GENTRY INNERSPACE DEVELOPMENT

MASTER DRAINAGE REPORT

Subject: Revised Master Drainage Report, Gentry Innerspace
Development

GENTRY INNERSPACE DEVELOPMENT
MASTER DRAINAGE PLAN (REVISED)

- DRAINAGE PLAN 88-2-73**
- MAJOR BASIN BOUNDARY
 - SUB-BASIN BOUNDARY
 - SOIL TYPE BOUNDARY
 - (RB-2 (D)) SOIL TYPE & HYDR. GROUP
 - III A SUB-BASIN NO.
 - (6.7) SUB-BASIN FLOW
 - FLOW DIRECTION
 - R.C.P.
 - OPEN CHANNEL
 - FLOW AT POINT IN C.F.S.
 - GRASS LINED SWALE

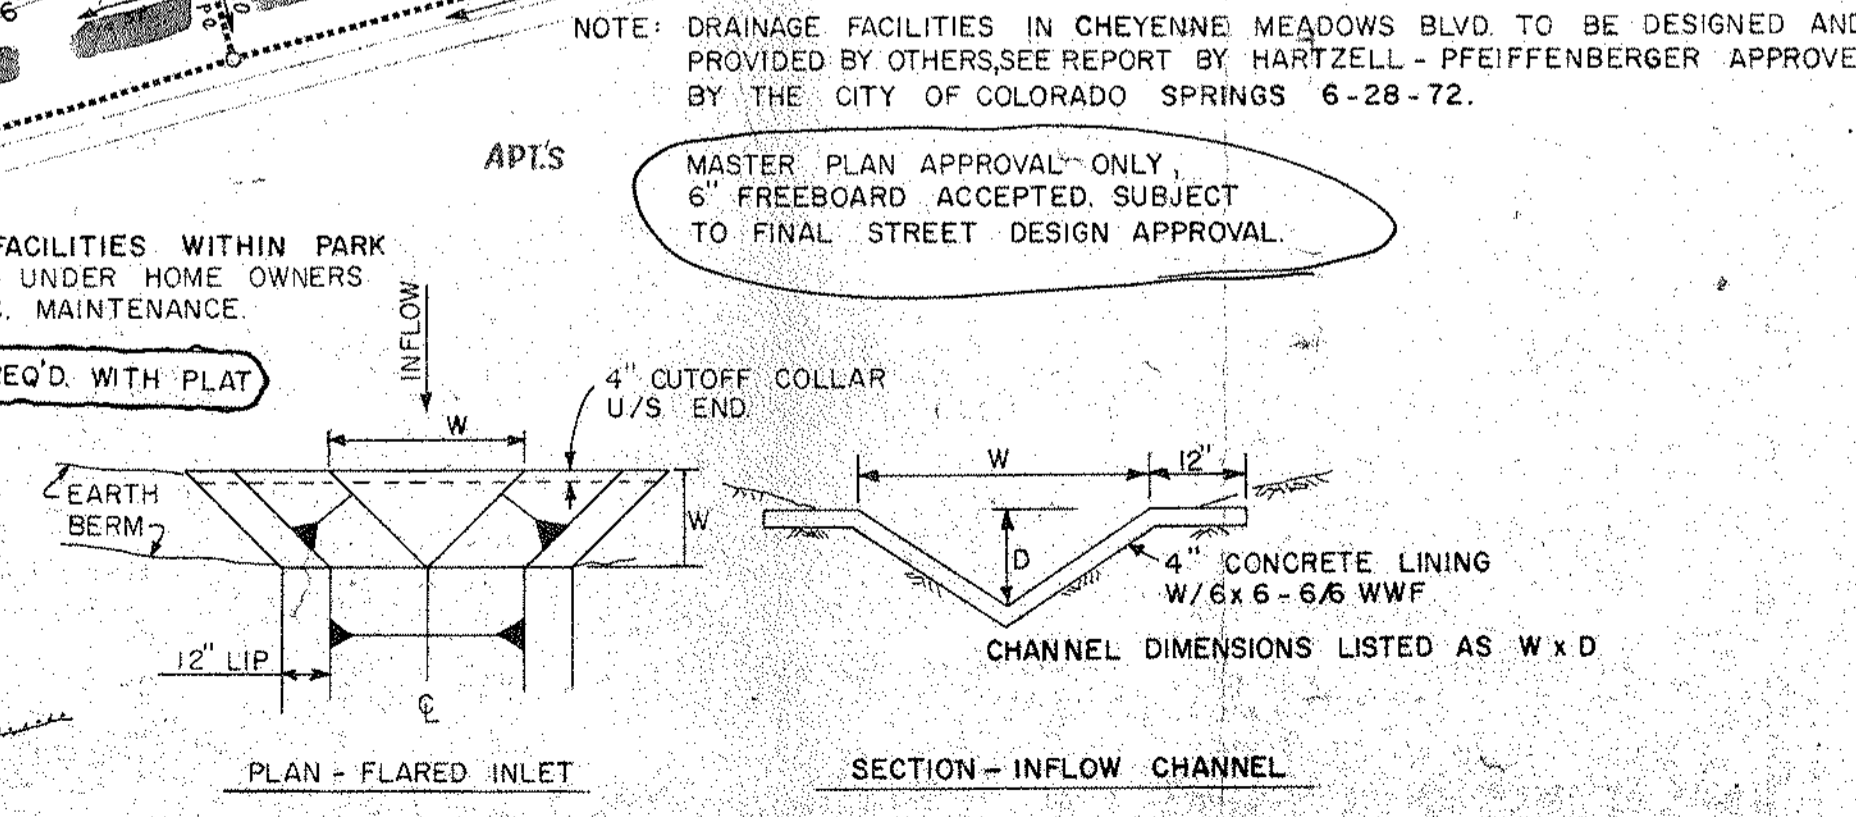
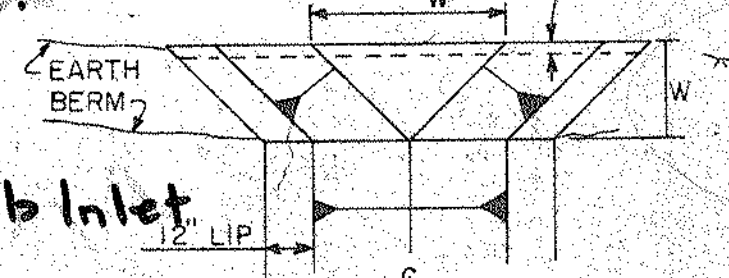
NOTE: CIRCLED COMMENTS REQUIRED BY CITY ENGINEER. REV. 2-19-73

ADD NOTE:
ALL SHEET FLOW DRAINAGE WILL
BE THE RESPONSIBILITY OF THE
DEVELOPER - AND WILL NOT
BE RECEIVED BY THE CITY OF CS.

NOTE: FOR THESE
FLOWS - WHY DON'T YOU
USE A PAVED SWALE
RATHER THAN
THE FLOW
AND PUT IN THE STREET.

Velocity Control
to Outlet

Master Plan Approval Only
6" Freeboard accepted.
Subject to Final Street
Design Approval

ALL FACILITIES WITHIN PARK
TO BE UNDER HOME OWNERS
ASSOC. MAINTENANCE.
Detail Reg'd with
Plat.
